**Agenda Item 3**  
**730 Washington Road**  
**New Residence – Revisions to Previously Approved Plans**

TO:	Members of the Historic Preservation Commission
DATE:	October 28, 2021
FROM:	Jennifer Baehr, Planner
SUBJECT:	<b>730 Washington Road</b> – Revisions to Previously Approved Plans

TO:	Members of the Historic Preservation Commission
DATE:	October 28, 2021
FROM:	Jennifer Baehr, Planner
SUBJECT:	<b>650 Lake Road – Partial Demolition, Additions, Exterior Alterations and a Building Scale Variance</b>

TO:	Members of the Historic Preservation Commission
DATE:	October 28, 2021
FROM:	Jennifer Baehr, Planner
SUBJECT:	<b>425 Sheridan Road - New Detached Garage, Additions, Exterior Alterations and Building Scale and Height Variances</b>

PREVIOUS TWO-STORY ITERATION:

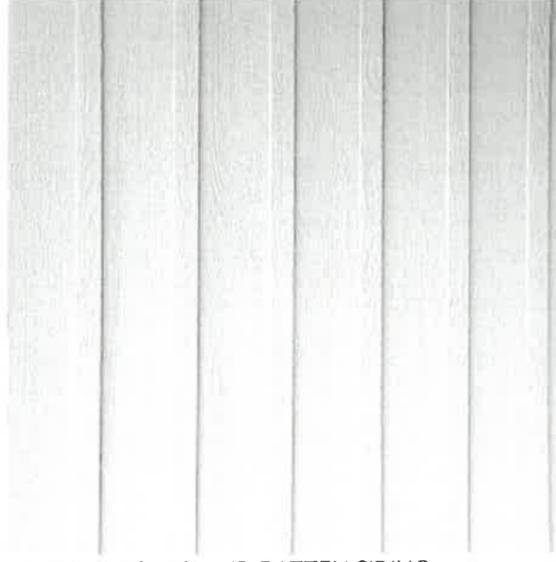
Aluminum clad windows changed from black to a pale off-white. We added panel gray paneled shutters, where appropriate.

While developing the design of Joan DePree's new home, it became clear that there were more bedrooms than needed or that would be used. One of the main drivers leading Joan to relocate from her beloved current home was to downsize. The proposed house was originally designed with five bedrooms, all en suite. In an effort to reduce the scale of the house, it was decided to remove the two en suite bedrooms on the second floor of the main house. With the removal of these two bedrooms, we also lowered the ridge of the main roof. While we will leave the attic unfinished in this project, it would be possible to build out the attic into habitable space in the future.
